## Explanation of Significant Differences

# RICHARDSON HILL ROAD LANDFILL SITE

Towns of Sidney and Masonville  
Delaware County, New York

June 2008

FIGURE 9B

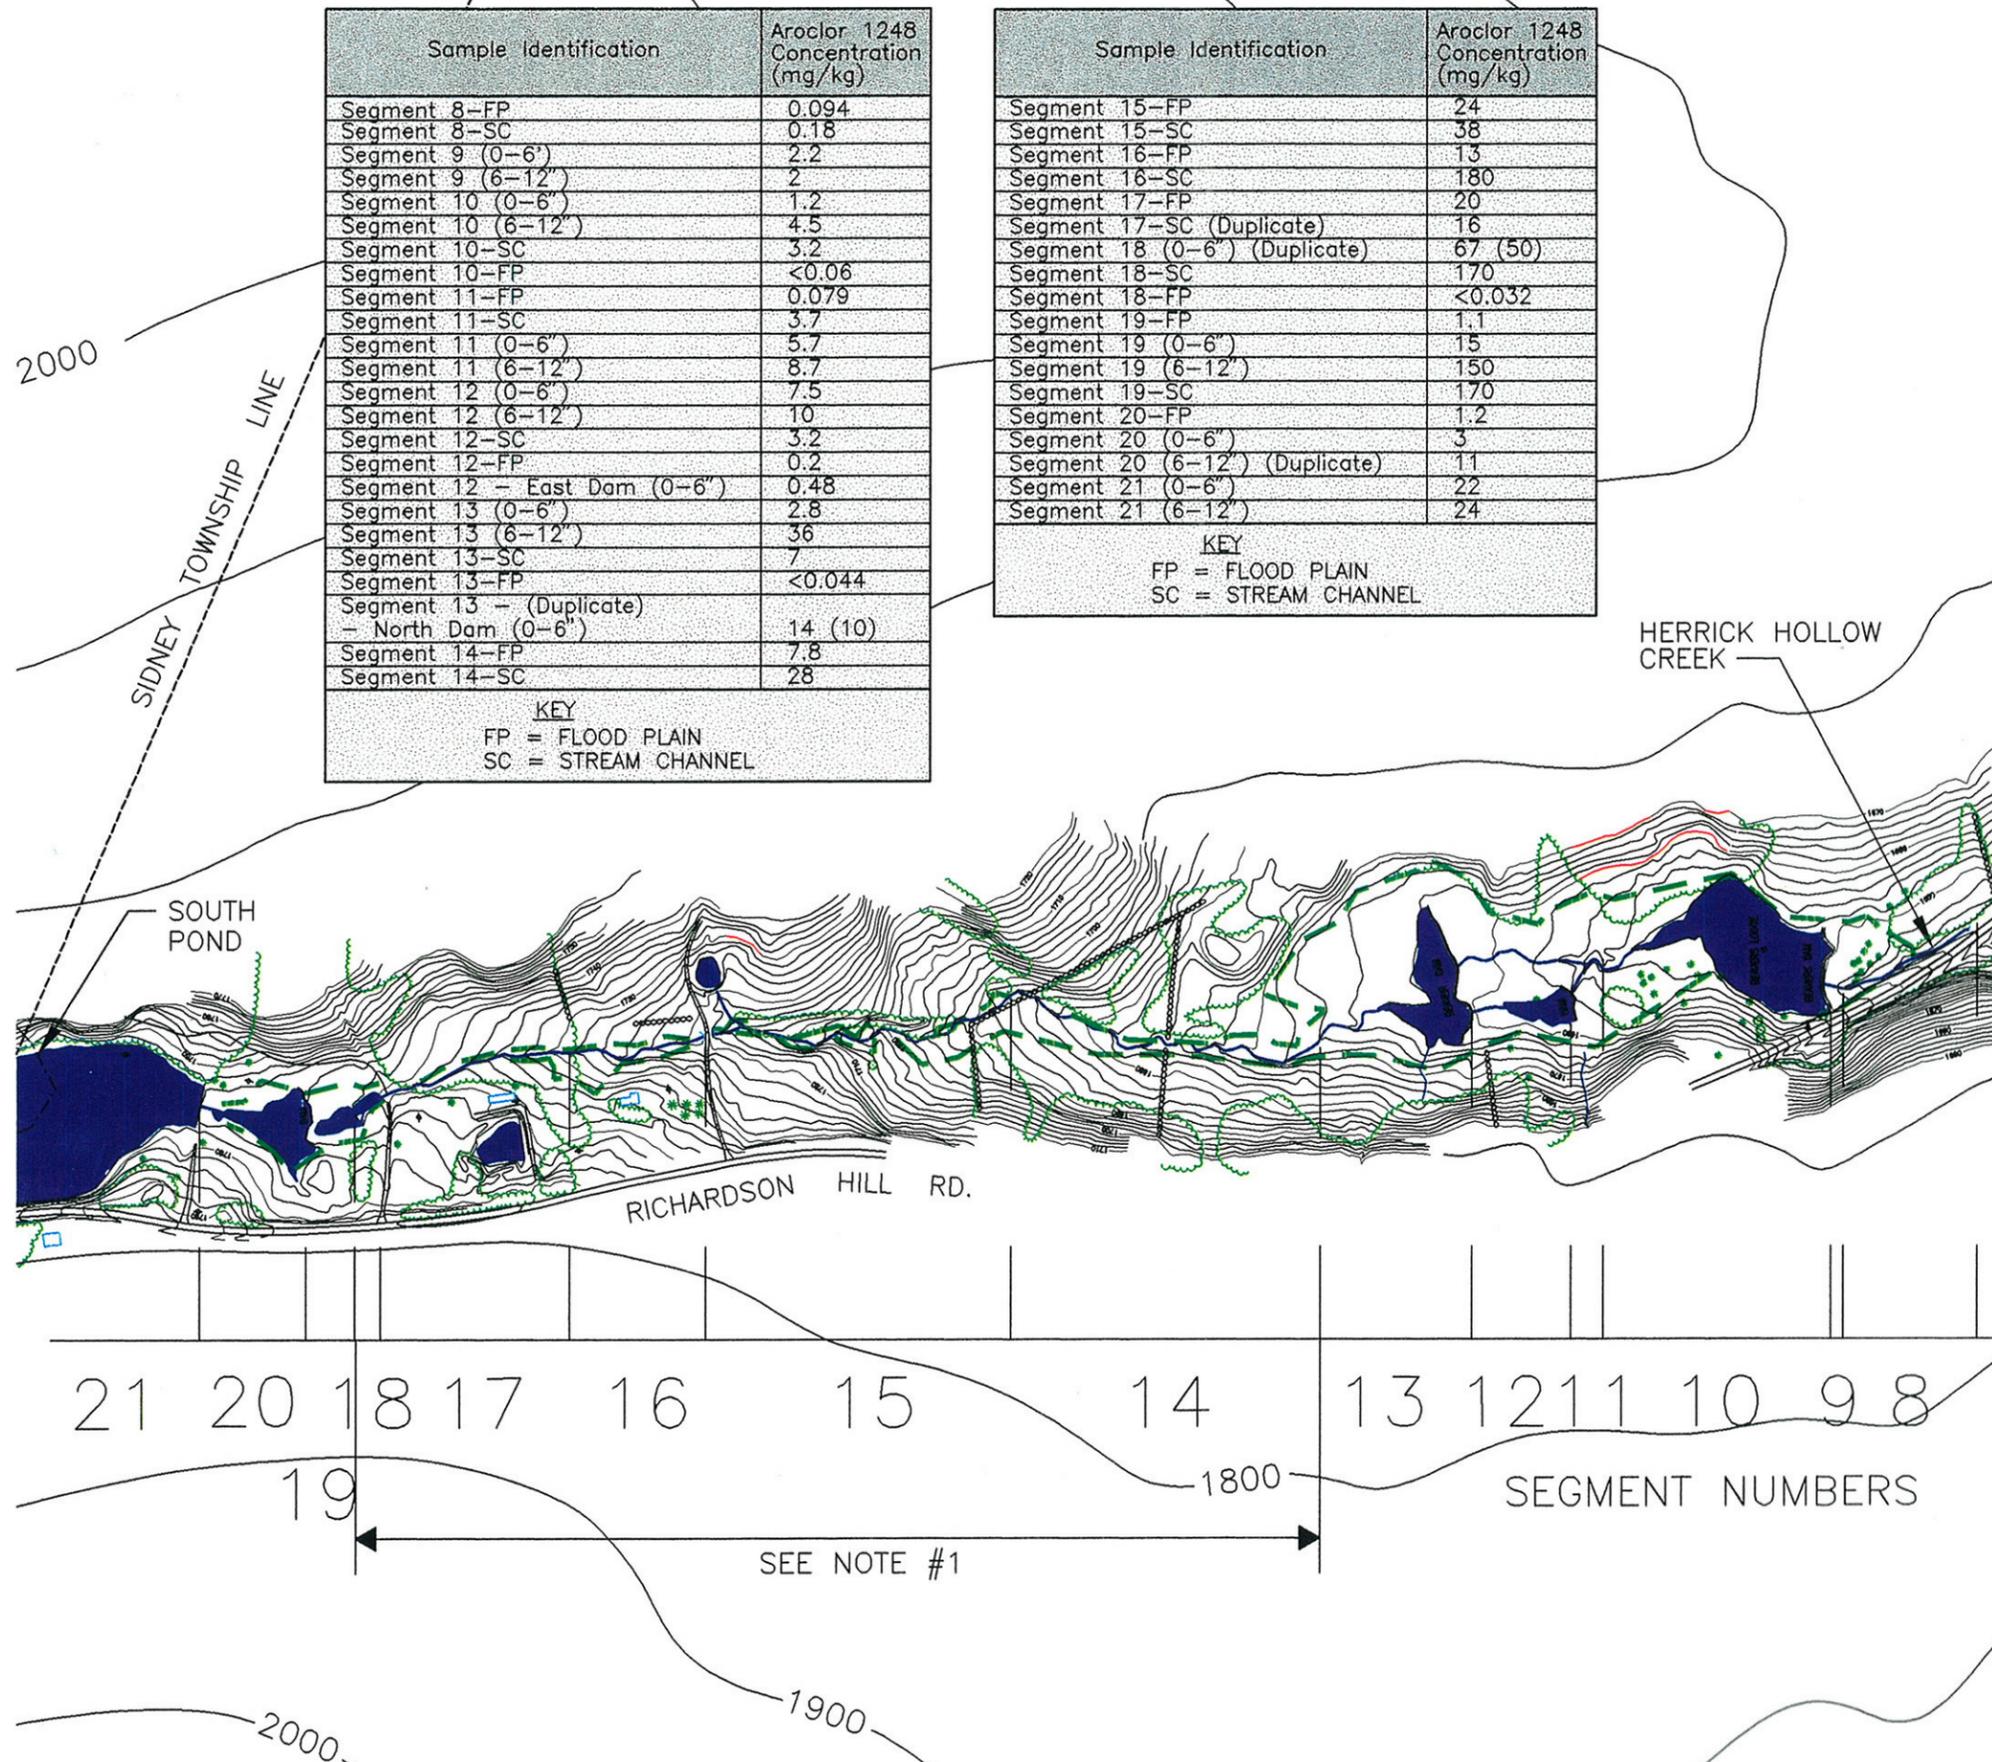
The ROD called for the excavation and/or dredging of sediments exceeding 1 milligram/kilogram PCB from South Pond and Herrick Hollow Creek downstream for approximately 2,400 feet (Segments 21 to 14 on the figure). The ROD also stated that the need for remediation in areas further downstream (i.e., Segments 13 to 9) would be evaluated based on an assessment of sediment, surface water, and biological receptors over the 5-year time period subsequent to the completion of upstream remediation activities. Further remediation would be required in Segments 13 to 9 if it was determined through monitoring that the

During the design investigation in 2002, in consideration of the possibility that the PCB-contaminated sediments in Segments 13 to 9 would still need to be removed in the future after years of monitoring and the cost savings associated with the elimination of the long-term monitoring related to all of the contaminated sediments once they are removed, as well as the willingness of the Settling Defendants to undertake the additional sediment removal work at this time, EPA and NYSDEC decided to remove the contaminated sediments in Segments 13 to 9 concurrently with the contaminated sediments in Segments 21 to 14.

Approximately 8,200 cubic yards of PCB-contaminated sediment were removed from Segments 13 - 9. The estimated cost associated with this effort was \$1 million. It is estimated that the annual cost saving associated with the elimination of the long-term monitoring related to all of the contaminated sediments once they are removed is \$60,000.
